HAMILTON CITY COUNCIL SUBMISSION

Land Transport Rule: Traffic Control Devices (Bilingual Signs) Amendment 2023 - Draft for Consultation

Waka Kotahi NZ Transport Agency

30 June 2023

| <p>W2-1.10 Hazard warning supplementary - signals not working</p> <p>Proposed Rule reference: clause 2.3(5)(dd)</p> |  |  |

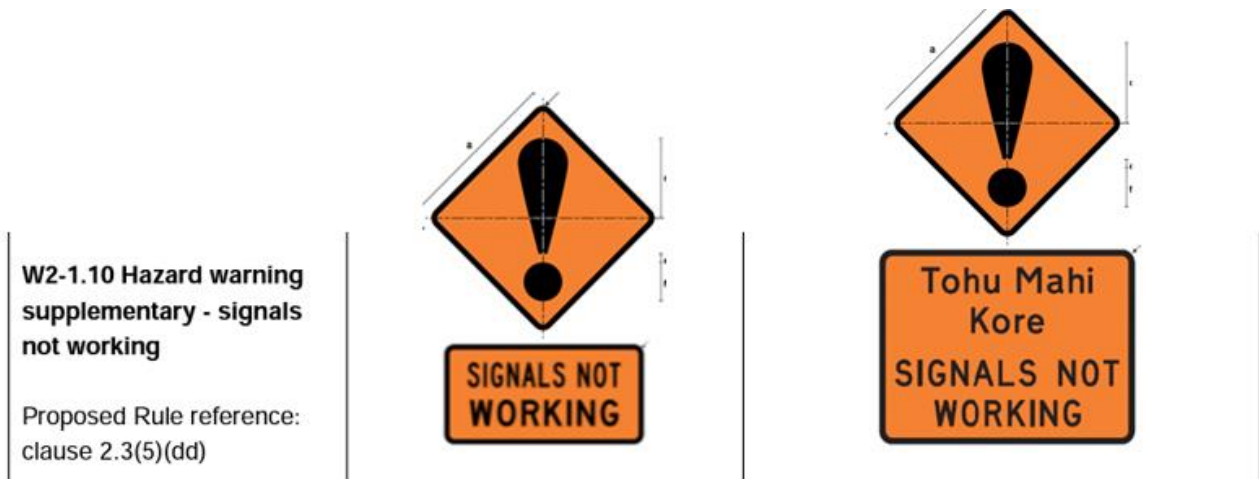
28. Most of the warning signs included in the proposal show just the supplementary element of a sign set, and do not show the implications when combined with the primary warning sign. For example, this supplementary sign proposal:

...should look like this in the correct size and scale, and including the required primary signs as they will be used on the network:

When the full sign set is correctly portrayed, the full implication of the proposals become clear, including that the above sign set increases from 1.5m tall to almost 2m tall. The industry has advised us that each sign will have to have bespoke stands to fit the new sign sizes, and indicated that the entire unit will now require replacement instead of supplementary signs only.
